**Car Stereo  
Service Bulletin**

**Model:** CDX-A15/A15RF/A30/A30RF/A40RF/A100

**No. 250**

**Subject:** Disc Passes Beneath Disc Stopper, E-04 or E-99  
Is Displayed

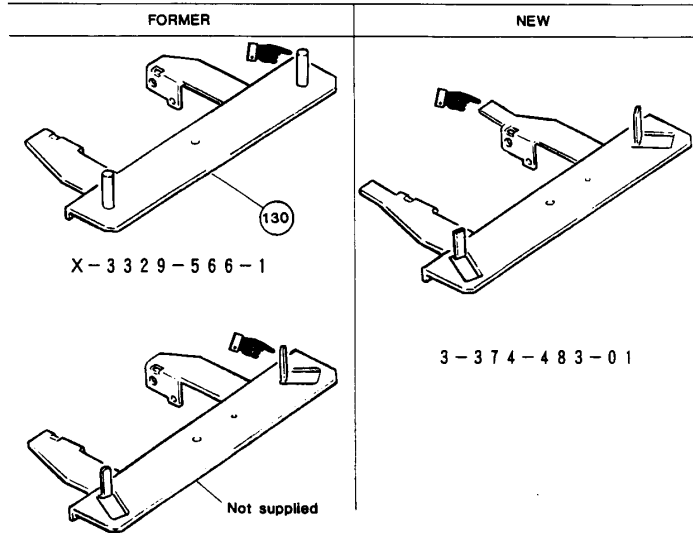
**Symptom:**  
(61)

During disc loading, the disc may pass beneath the disc stopper and cannot be read. Additionally, the mechanism may not be able to return the disc to the magazine.

**Solution:** Replace the disc stopper with an improved version:

REFERENCE	DESCRIPTION	PART NUMBER	
		FORMER	NEW
— (CDXA15/A15RF/A40RF)	STOPPER, DISC	—	3-374-483-01
130 (CDX-A30/A30RF/A100)	STOPPER, DISC	X-3329-566-1	3-374-483-01
